SYDNEY WEST JOINT REGIONAL PLANNING PANEL

JRPP No. 2014SYW042

Development Application No. 15.1/2014

Street Address 184-192 Restwell Road, Prairiewood

Figure 3: Extract from DA Architectural Drawing SI-6

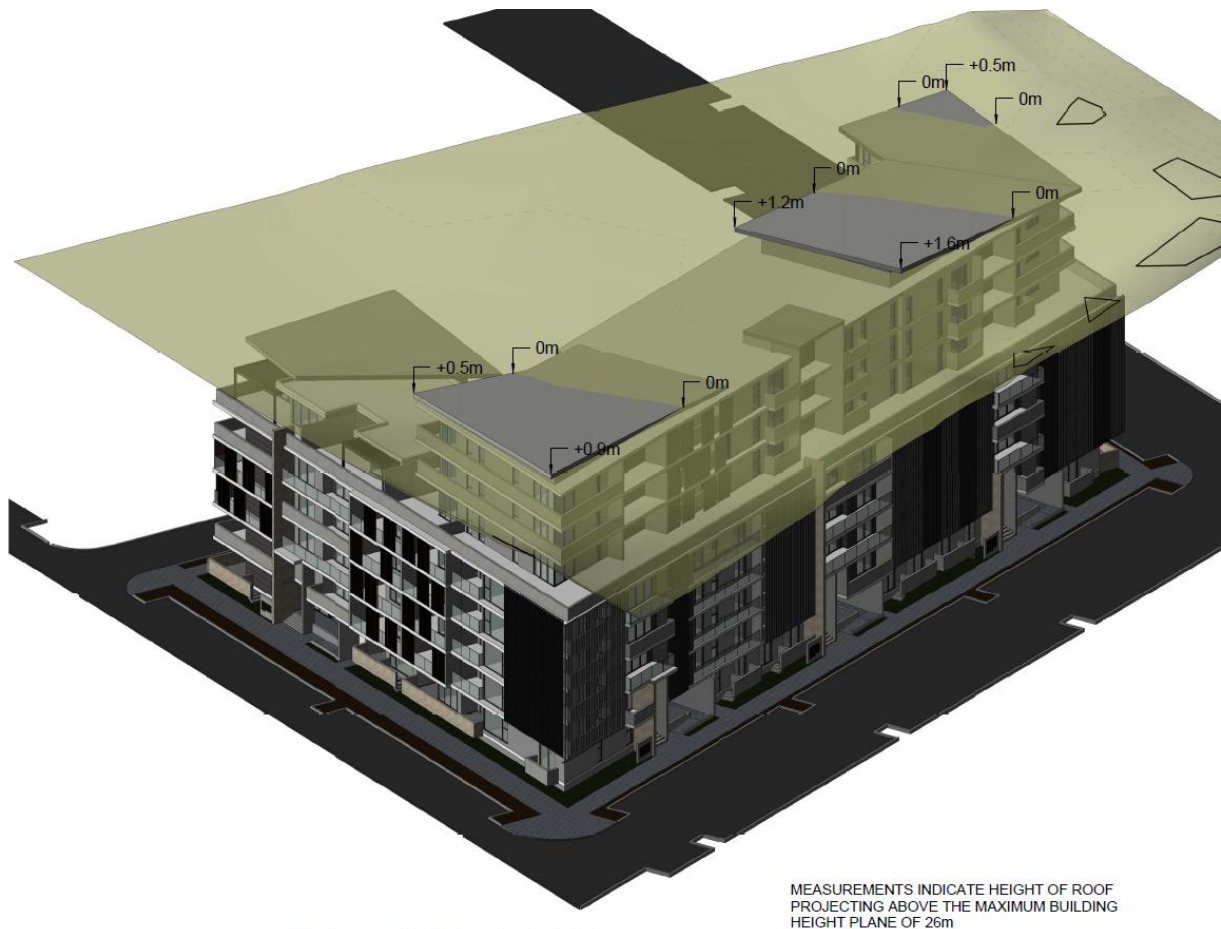
The diagram in Figure 3 is an extract of an image provided in the drawings submitted with the amended DA which illustrates the extent of non-compliance with the maximum height control (the non-compliant elements are represented by the grey coloured areas of the roof).

Comment: The roof form of the development is the element of the proposed building that breaches the maximum height plane. The roof form is considered to have good architectural merit and complements and enhances the design of the overall building. Allowing flexibility in applying the height standard in this instance will result in an improved planning outcome.
